Reducing the PMD Types of Downstream

Overview

Power and Wavelength Range (D2.0 and 2.1)

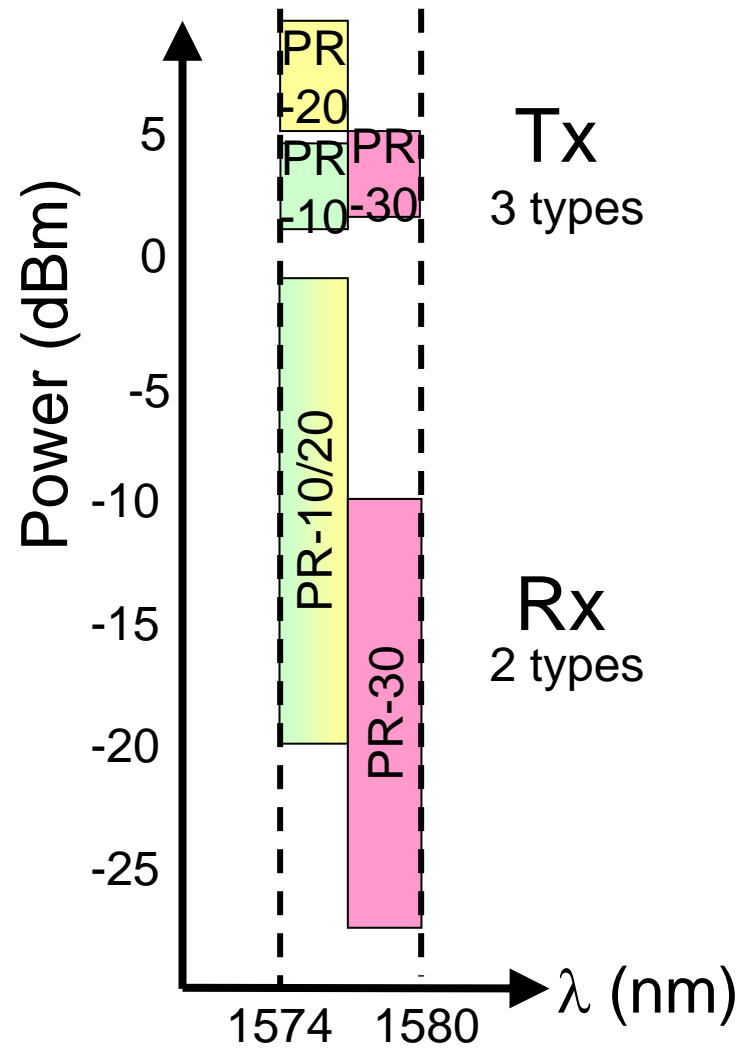
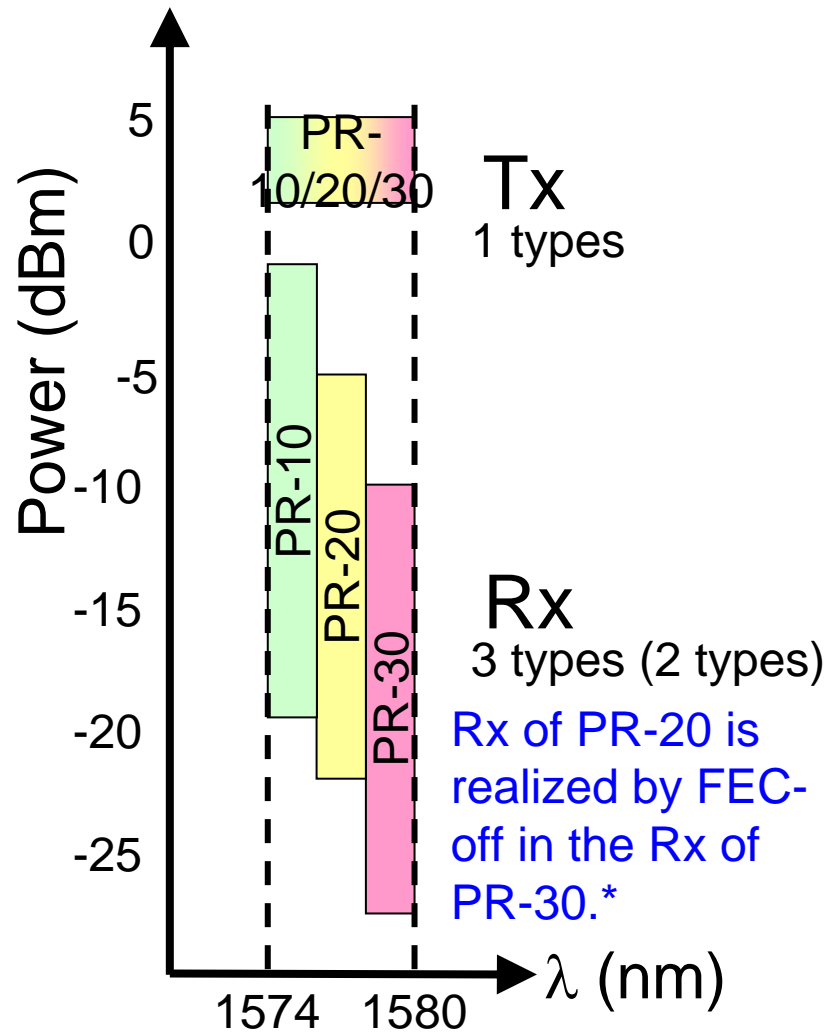
- In the September meeting at Seoul, the downstream wavelength ranges were unified to 1577 +/- 3 nm.
- The power budgets of the downstream should be reconsider on this occasion.
- Current draft specifies 3 types of transmitter and 2 types of receiver in downstream.
 - DS Tx
 1. 10GBASE-PR-D1 (EML)
 2. 10GBASE-PR-D2 (EML + Optical Amplifier)
 3. 10GBASE-PR-D3 (EML)
 - DS Rx
 1. 10GBASE-PR-U1 (PIN)
 2. 10GBASE-PR-U3 (APD)
- In order to realize low-cost PMDs, the types of PMD should be reduced.

Proposal 1 (Single Tx)

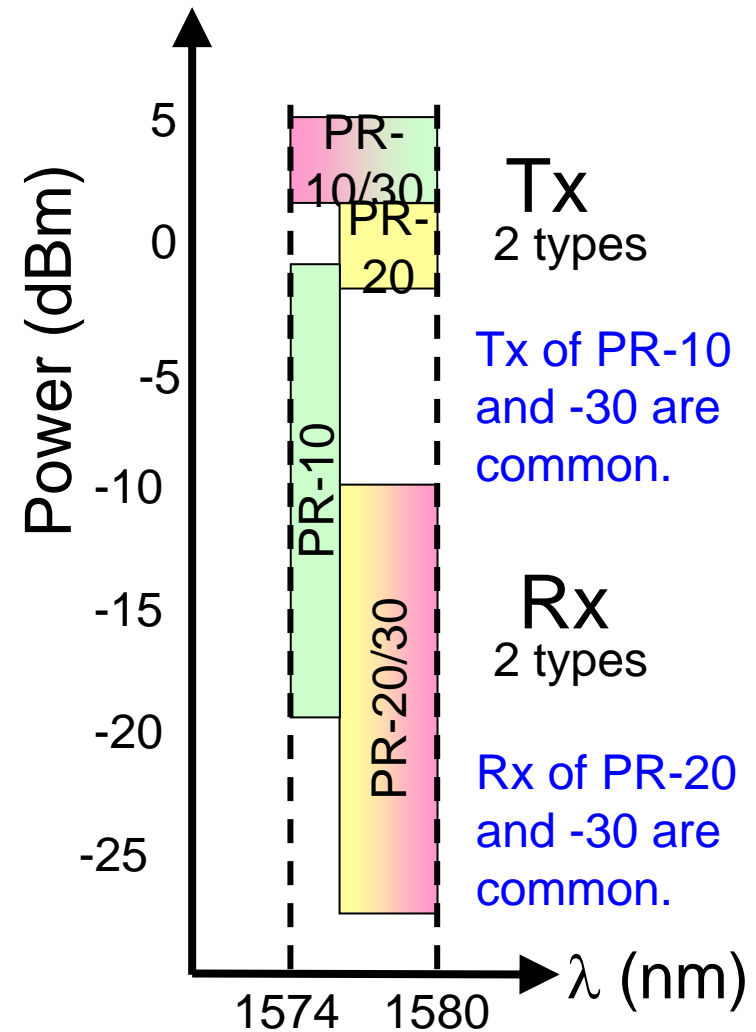
Red characters are change from D2.1

PR-10	PR-20	PR-30	Unit
OLT PMD transmit characteristic (excerpt from Table 75-5)				
Average launch power (max)	5	5	5	dBm
Average launch power (min)	2	2	2	dBm
Launch OMA (min)	3.91 (2.46)	3.91 (2.46)	3.91 (2.46)	dBm (mW)
ONU PMD receive characteristic (excerpt from Table 75-11)				
Average receive power (max)	0	-5	-10	dBm
Damage threshold (max)	1	-4	-9	dBm
Receiver sensitivity (max)	-19.5	-23.5	-28.5	dBm
Receiver sensitivity OMA (max)	-17.59 (17.42)	-21.59 (6.93)	-26.59 (2.19)	dBm (uW)
Stressed receive sensitivity (max)	-18	-22	-27	dBm
Stressed receive sensitivity OMA (max)	-16.09 (24.60)	-20.09 (9.79)	-25.09 (3.10)	dBm (uW)

- The power budgets of the downstream were reconsidered in order to reduce the PMD types.
- Two sets of power budgets were considered.
 - Single Tx
 - Low power Tx
- Common PMDs between other classes will suppress the cost through the mass production effect.
